Subject: Response to request for additional information and Revision 2 of application for
Renewal of Certificate of Compliance No. 9070

Response to NRC questions 71-9070, dated September 21, 1994

NuPac N-55 Consolidated

Docket 71-9070

Figure 1.3.2-1

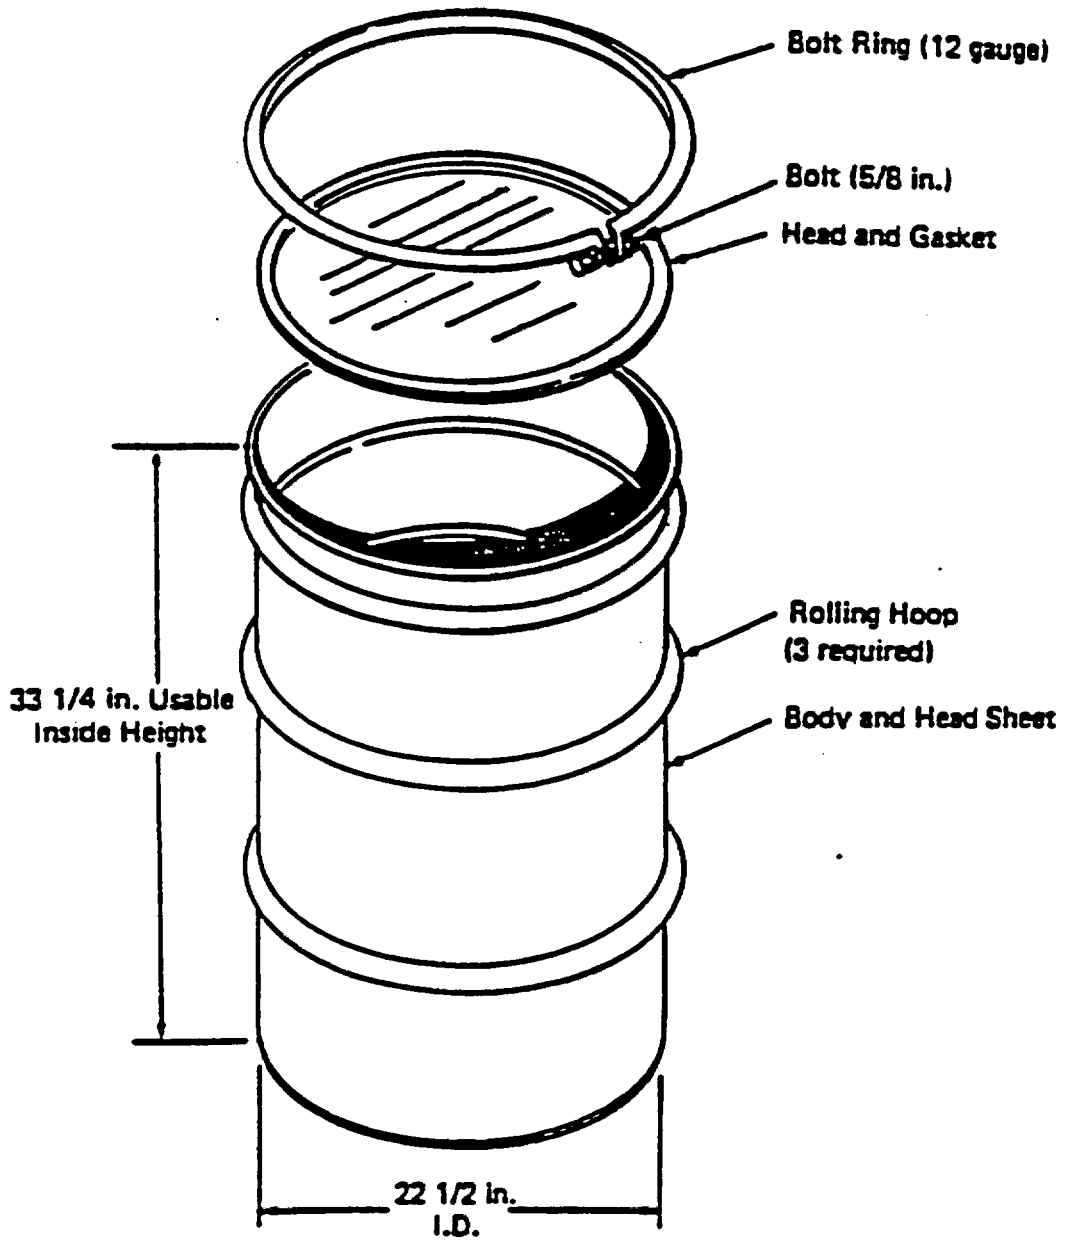
- 1. Provide an evaluation of the drum shown on sheet 4c, Rev. 1, of the application dated August 22, 1994. Compare the drum to the previously approved DOT Specification 17H and 17C drums. The evaluation should consider both the structural integrity of the drum, and the containment function provided by the drum.**

- 2. Revise the sketch of the drum on sheet 4c, Rev. 1, to specify the gasket required for the drum closure. Include any leak testing provisions for the drum.**

An evaluation of the current drum, along with a comparison to the previously approved DOT Specification 17H is provided with a more detailed drum specification.

Gaskets required and leak testing provisions are contained in the detailed drum specification. The drawing on sheet 4c is now Figure 1.3.2-1 on page 4g and only represents typical dimensions.
